MIPS R4400PC/SC Errata, Processor Revision 1.0

February 9, 1994

Figure 1a: Power-on Reset or Cold Reset - Workaround for Bug# 22

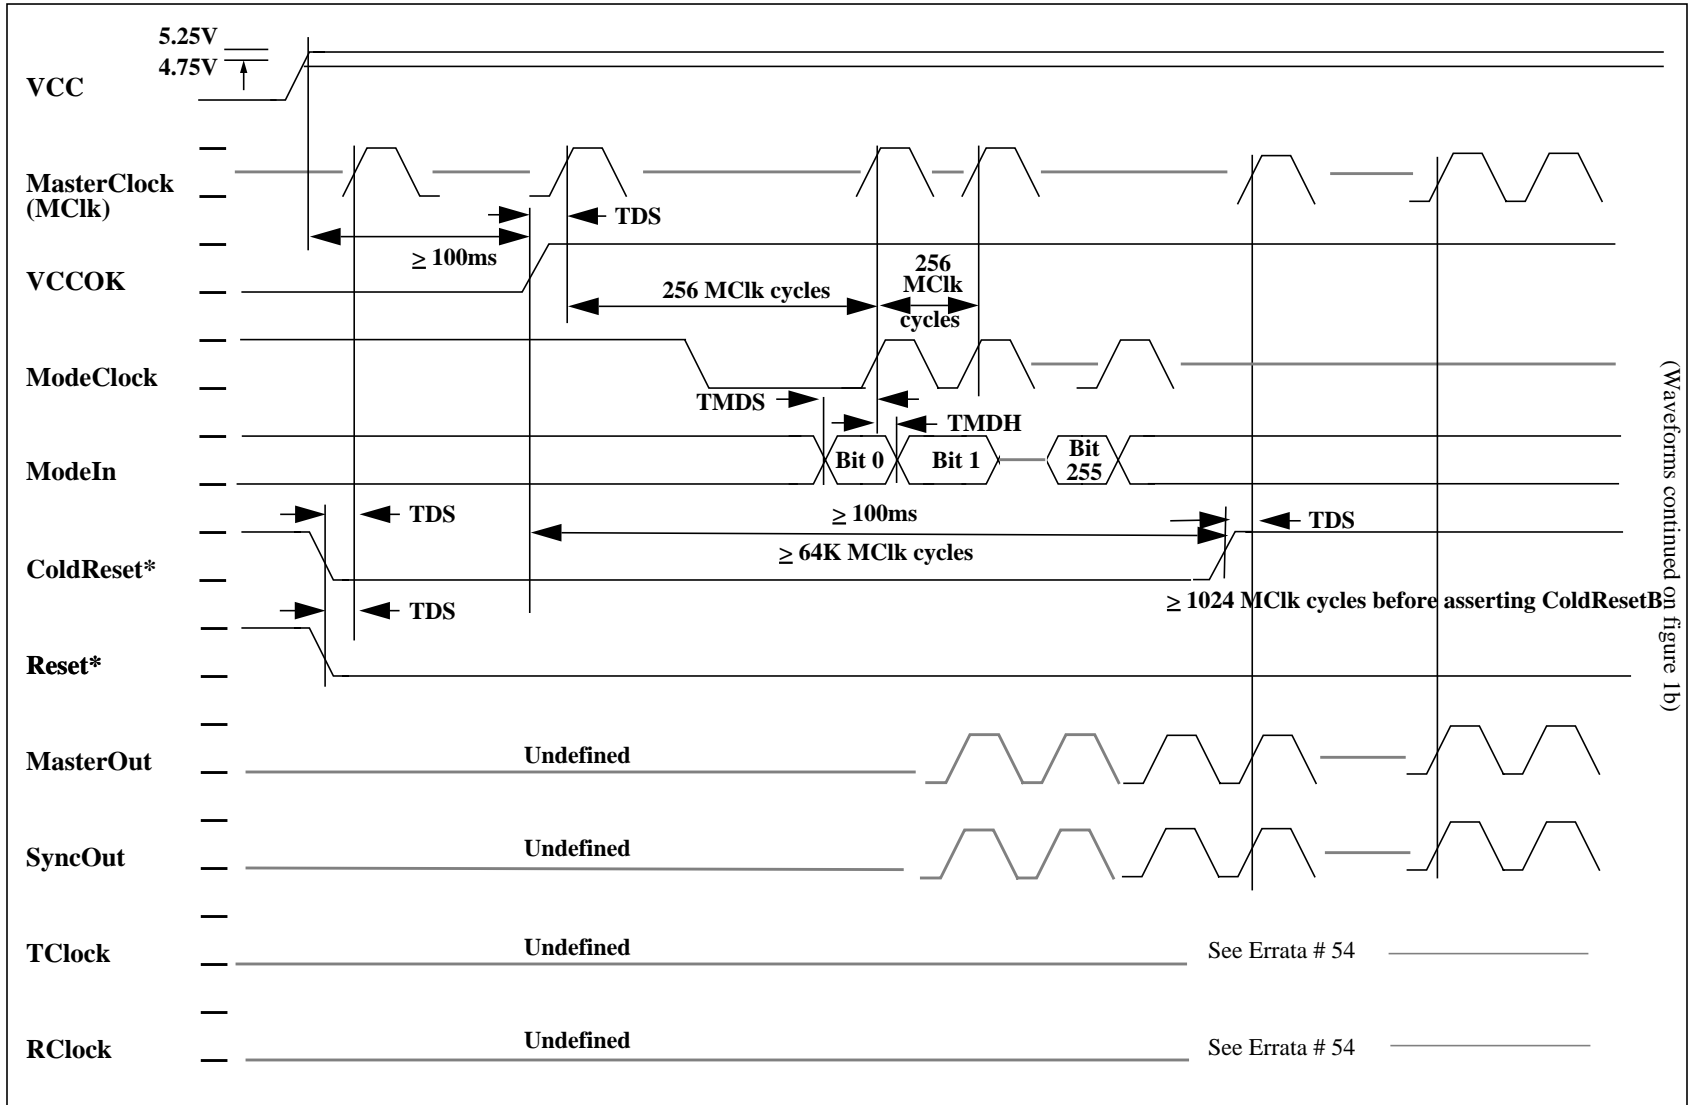
22. R4400PC, R4400SC: During the power up sequence, the period of TClk and RClk may not be as expected for at least 1024 MasterClock cycles following the de-assertion of ColdResetB. The above bug is true for all system interface divisors. Furthermore, if the system interface divisor other than 2 (i.e. 3,4,6 & 8) is used, TClk and RClk's rising edge may not align to the rising edge of the MasterClock, as specified.

Thus, for system with interface divisor set to two, the only violation will be that the TClk and RClk's period might not be valid within 64 MasterClock after the ColdResetB is de-asserted.

Workaround: Assert a second ColdResetB after at least 1024 MasterClock cycles from the de-assertion of the first ColdResetB. ResetB should remain asserted until at least 64 MasterClock cycles following the de-assertion of the second ColdResetB. TClk and RClk will then be valid 64 MasterClock cycles after the de-assertion of the second ColdResetB and their edge alignment with respect to MasterClock will be as specified. Figure 1a & 1b show the waveforms in more detail. Note that the waveforms in Figure 1b are continuation of the those in figure 1a.
